DESIGN #	DRAWN BY CP	<b>DART AEROSPACE LTD</b> HAWKESBURY, ONTARIO, CANADA	
CHECKED #	APPROVED #	DRAWING NO. DSI 9273	REV. A SHEET 1 OF 1
DATE 04.02.02		TITLE ADD D350-607-045	SCALE NTS

## **DART SERVICE INSTRUCTION**

**TO AMEND INSTALLATION DRAWING D350-607 REV. F**

REF. CANADIAN STC: SH92-14

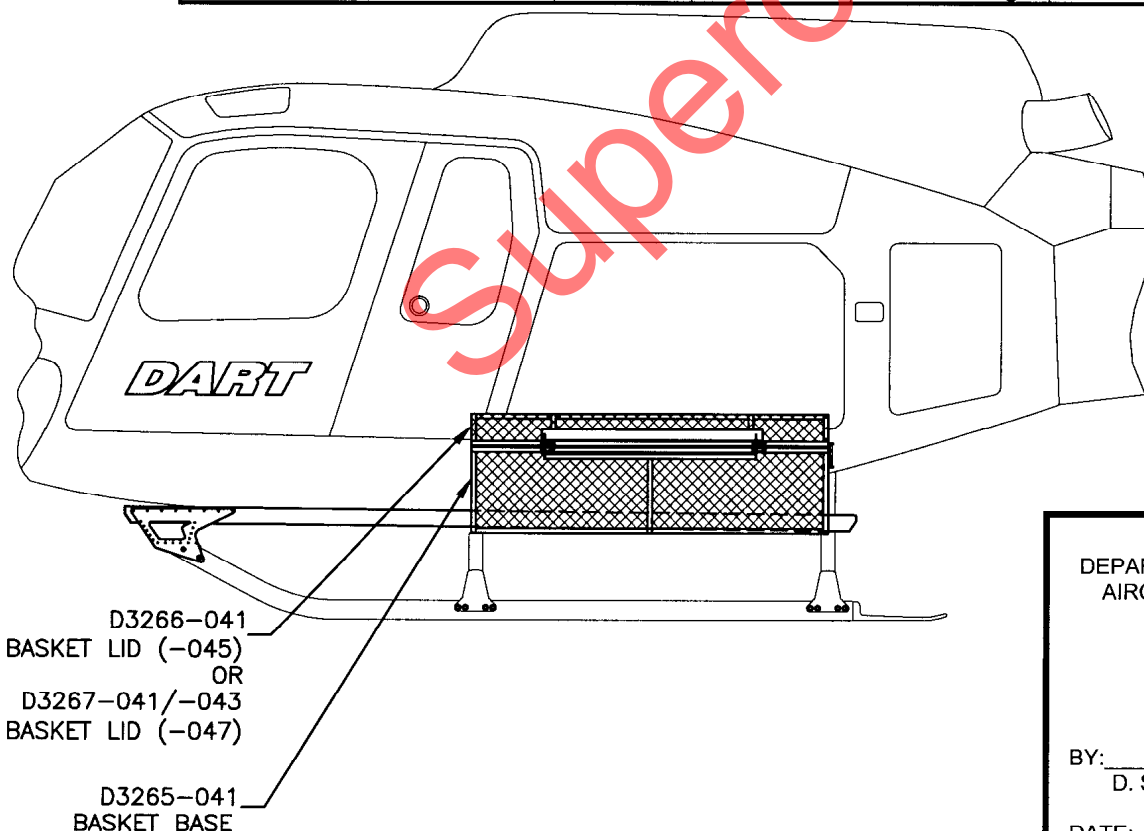
Add D350-607-045 and D350-607-047 to D350-607 Rev.F. Install and maintain D350-607-045/-047 the same as D350-607-041/-043. Parts list for D350-607-045 is same as D350-607-041, except that D3265-041 Base replaces D2221 Base and D3266-041 Lid replaces D2512 Lid. Parts list for the D350-607-047 is the same as D350-607-043 except that D3265-041 Base replaces D2221 Base and D3267-041/-043 Lid replaces D2989-041/-043 Lid. Weight & balance for D350-607-045/-047 is as follows:

Installation	Weight	Lateral		Longitudinal	
		Arm	Moment	Arm	Moment
D350-607-045 <i>Heli-Utility-Basket™</i>	65.0 lb 29.5 kg	±48 in ±1.22 m	±3120 in-lb ±36.0 m-kG	135 in 3.43 m	8775 in-lb 101.2 m-kG
D350-607-047 <i>Heli-Utility-Basket™</i>	65.0 lb 29.5 kg	±48 in ±1.22 m	±3120 in-lb ±36.0 m-kG	135 in 3.43 m	8775 in-lb 101.2 m-kG
